DART AEROSPACE LTD	Work Order:	96955
Description: Crosstube Assembly (412 High Aft)	Part Number:	D412-664-243
Inspection Dwg: D412-664-243 Rev: E		Page 1 of 2

DRAWING NO. D412-664-243		TITLE CROSSTUBE ASSEMBLY (412 HI AFT)		REV. E DART AEROSPACE LTD ENGINEERING ORDER		D.E.O. NO. D412-664-243-E-1		SHEET NO. SHEET 1 OF 2		SCALE NTS	
DRAWN		CHECKED		MFG. APPR.		APPROVED		DE APPR.			
DATE 11.03.31		DATE 11/03/31		DATE 11.03.31		DATE 11/03/31		DATE 11.03.31

DRAWING NO. D412-664-243	TITLE CROSSTUBE ASS'Y (412 HI AFT)	REV. E	DART AEROSPACE LTD ENGINEERING ORDER		D.E.O. NO. D412-664-243-E-2	SHEET NO. SHEET 1 OF 1	SCALE NTS
DRAWN <i>MP</i>	CHECKED <i>ASS</i>	MFG. APPR. <i>RE</i>	APPROVED <i>MP</i>		DE APPR. <i>MP</i>		
DATE 11.09.07	DATE 11.09.19	DATE 11.09.19	DATE 11.09.19		DATE 11.09.19

DRAWING NO. D412-664-243	TITLE CROSSTUBE ASSEMBLY (412 HI AFT)	REV. E	DART AEROSPACE LTD ENGINEERING ORDER		D.E.O. NO. D412-664-243-E.4	SHEET NO. SHEET 1 OF 3	SCALE NTS
DRAWN 92	CHECKED A	MFG. APPR. A	APPROVED MP	DE APPR. MP			
DATE 12.08.21	DATE 12.08.30	DATE 12.08.30	DATE 12/8/30	DATE 12.08.30

**D412-664-243
ASSEMBLY DETAIL**

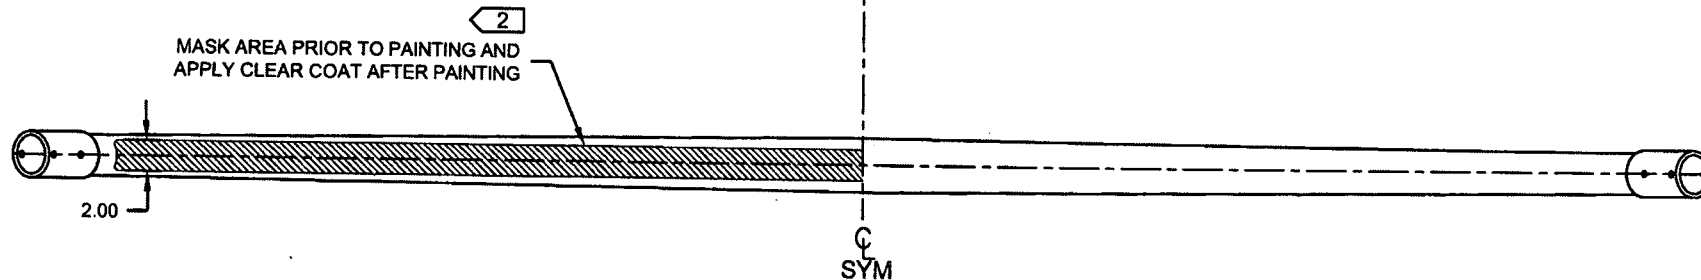
PURPOSE:

REMOVED ABRASION STRIP IN FAVOR OF A THIN LAYER OF PROSEAL 890.

NOTES 2 AND 14, SHEET 1 ARE AMENDED AS FOLLOWS:

IS:

D3189-1 CHAFING SHIELD (1, INSTALLED OVER PROSEAL 890)
MS21920-28 CLAMP, 2X
2 PL

WAS:

D2856-600-1009 ABRASION STRIP
D3189-1 CHAFING SHIELD (1, INSTALLED OVER ABRASION STRIP)
MS21920-28 CLAMP, 2X
2 PL

**D412-664-243
ASSEMBLY DETAIL**

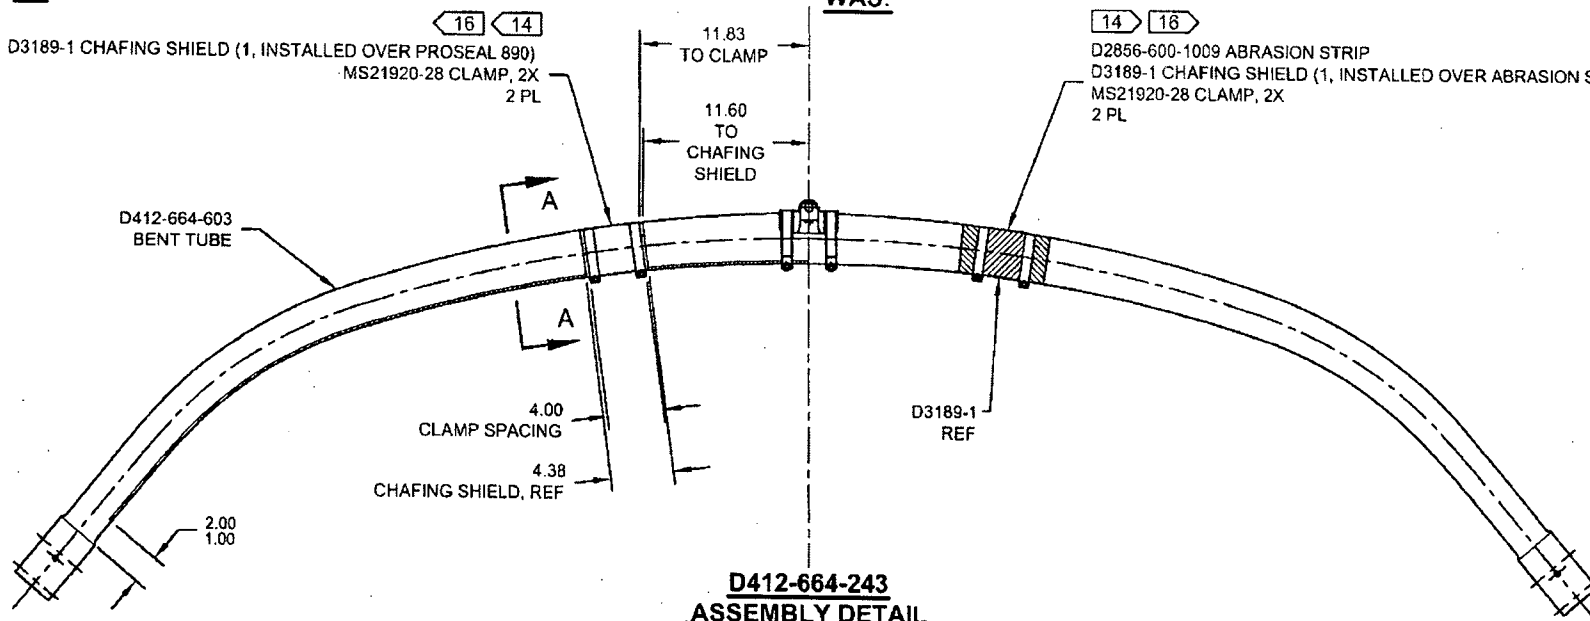
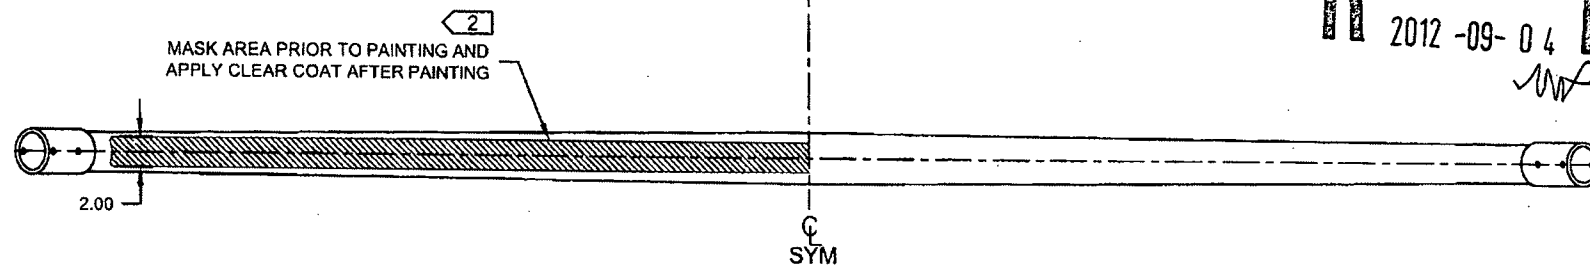
PURPOSE:

REMOVED ABRASION STRIP IN FAVOR OF A THIN LAYER OF PROSEAL 890. UPDATE INSTALLATION OF CHAFING SHIELDS AND REDUCE TORQUE TO 40-50 IN-LBS. THIS ENGINEERING ORDER SUPERCEDES DEO D412-664-243-E-1.

NOTES 2, 14, AND 16 ON SHEET 1 ARE AMENDED AS FOLLOWS:

IS:

D3189-1 CHAFING SHIELD (1, INSTALLED OVER PROSEAL 890)
MS21920-28 CLAMP, 2X
2 PL

WAS:

D2856-600-1009 ABRASION STRIP
D3189-1 CHAFING SHIELD (1, INSTALLED OVER ABRASION STRIP)
MS21920-28 CLAMP, 2X
2 PL
